UNITED STATES PATENT AND TRADEMARK OFFICE

10/601,040

Office Action Summary	Application No.	Applicant(s)	
	10/601,040	GREGOIRE, WAYNE JACOB	
	Examiner	Art Unit	
	Shelley Self	3725

DETAILED ACTION

FIG. 1

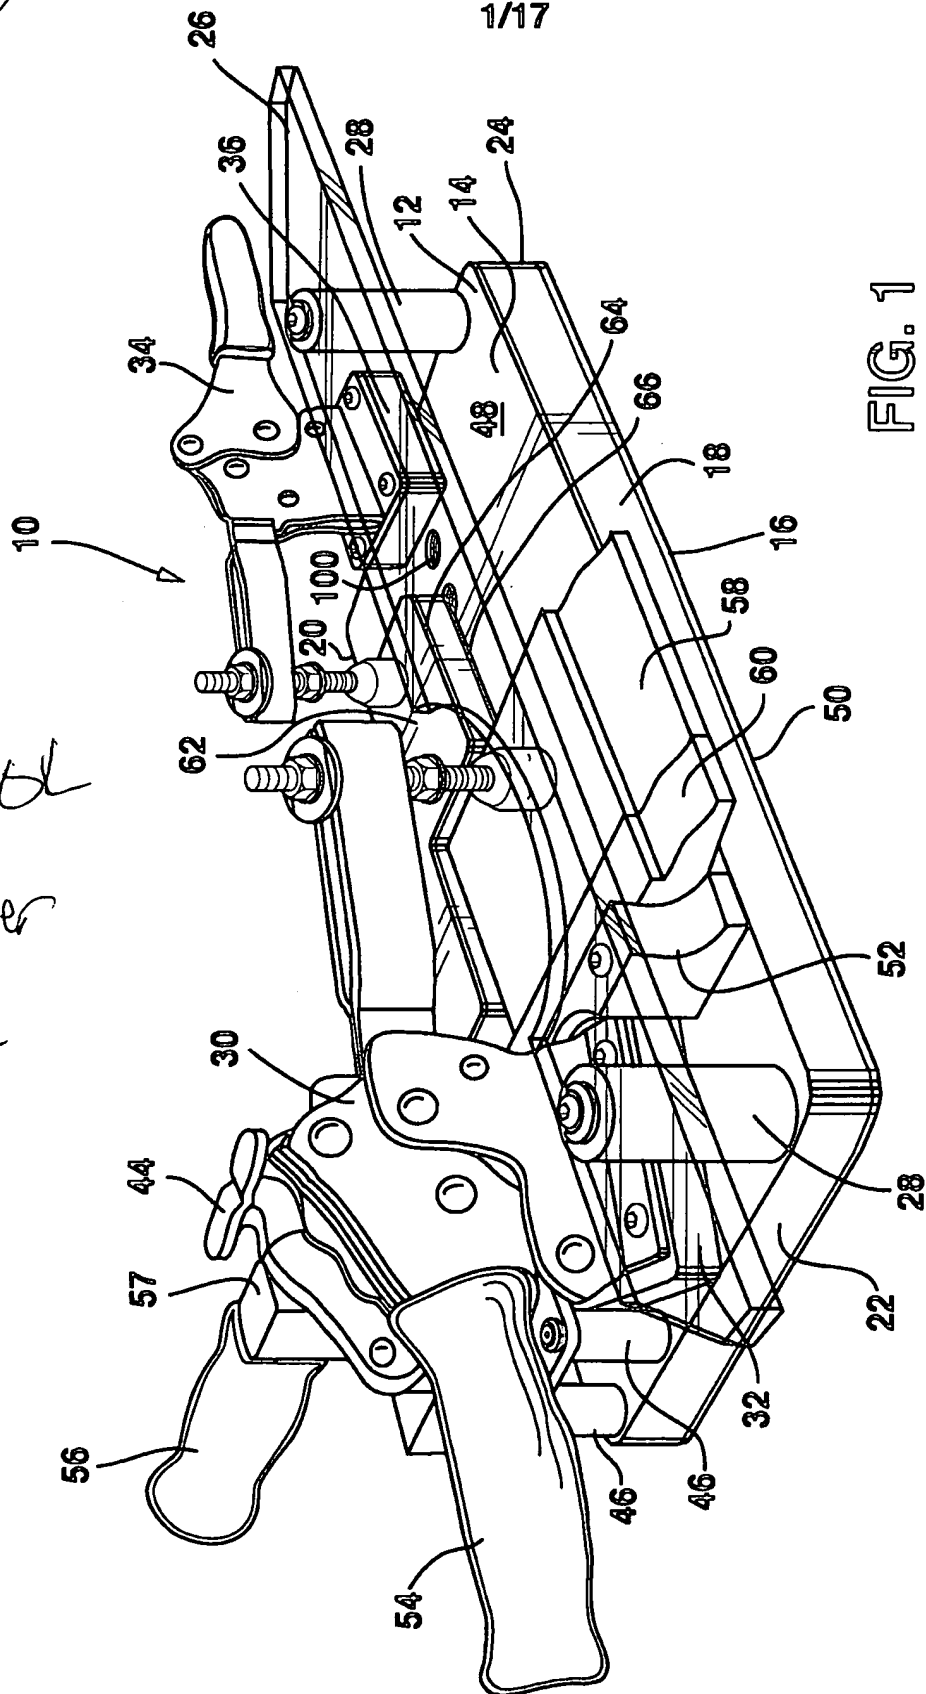
The Examiner approves the replacement drawings filed December 27, 2006.

Approved &
to Enter
Sheet
